SERVICE LETTER NUMBER 140			
TITLE: MAIN LANDING GEAR (MLG) THREADED COUPLER			
BY: S. ST. JACQUE	AIRCRAFT MAKE/MODEL(S): N/A	FLOAT MODEL(S): 3000, 3450	NOTE(S): OPTIONAL COMPLIANCE S/L P/N 1005862 ECO 23053
APP: D. GARRETT			
DATE: 03/15/13			
REV: A

FAA APPROVAL HAS BEEN OBTAINED FOR TECHNICAL DATA IN THIS PUBLICATION THAT AFFECTS STC OR TSO DESIGN COMPLIANCE

DETAIL A

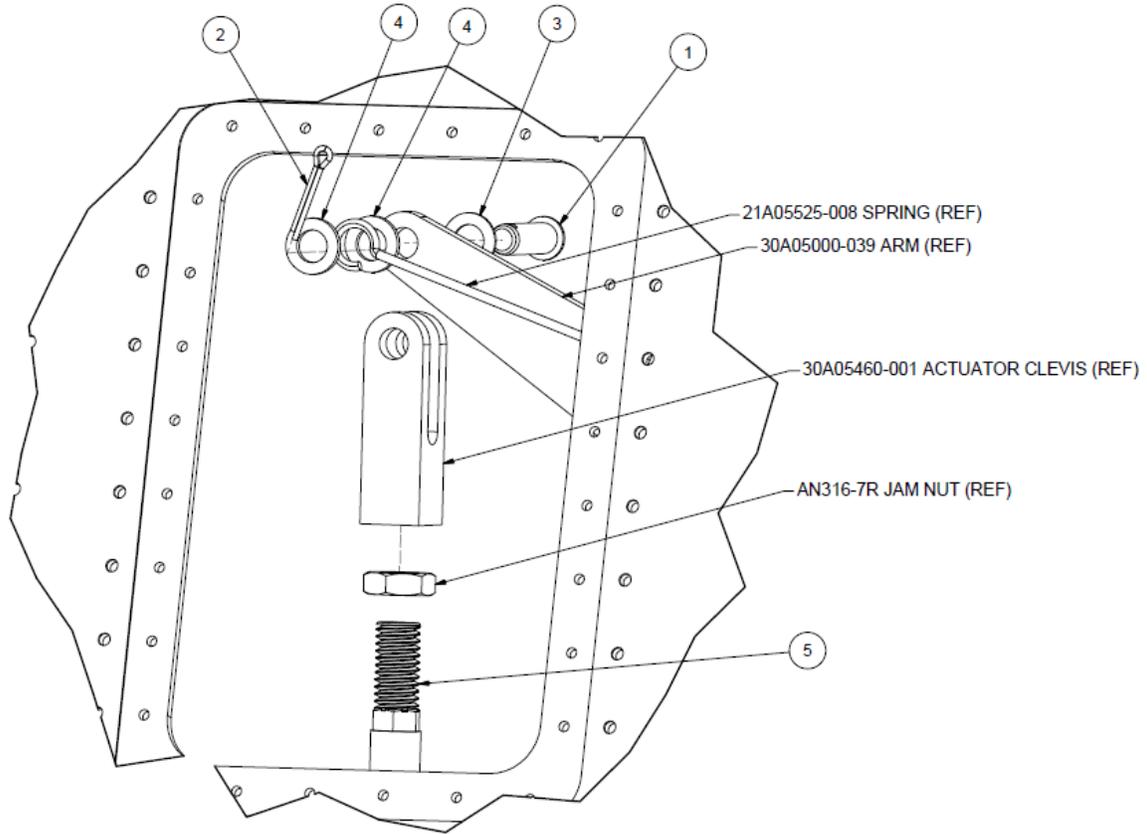
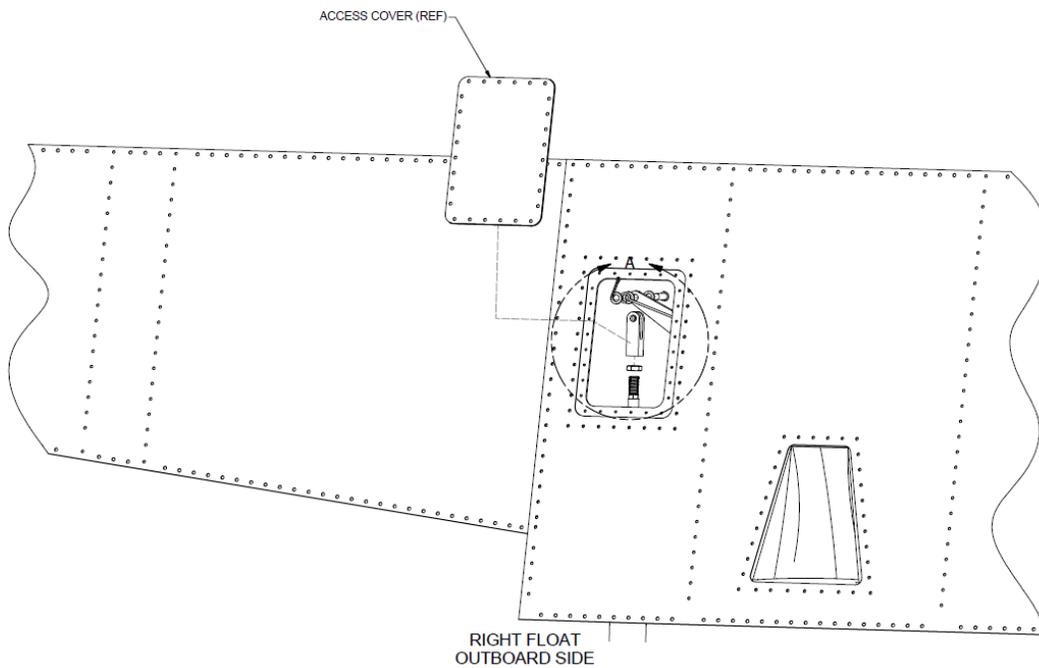
Corrosion may occur on the threaded connection between the Main Gear Hydraulic
Retract Actuator and connecting clevis. This service letter and associated kit replaces
the threaded connection with a stainless steel version of the same part. It also replaces
the connection hardware with a Clevis Pin instead of a bolted connection.

1. Perform the following service procedures after first securing airplane.
2. Jack up the Main Gear until the tire is not in contact with the ground. (refer to Float Service Manual Section 4.0)
3. Remove access cover as shown.
4. Remove Hydraulic Actuator Clevis and connection hardware. Discard hardware.
5. Remove and replace ASH-001WA Threaded Coupler with ASH-316ST.
6. Reuse jam nut on ASH-316ST.
7. Reattach Actuator Clevis to ASH-316ST.
8. Adjust rigging per 3000/3450 Wipaire Float Service Manual Section 5.2. www.wipaire.com
9. Coat the attach hardware with grease and install as shown.
10. Reinstall the access cover.
11. Lower float on to main gear and repeat the service procedure on the opposite float.
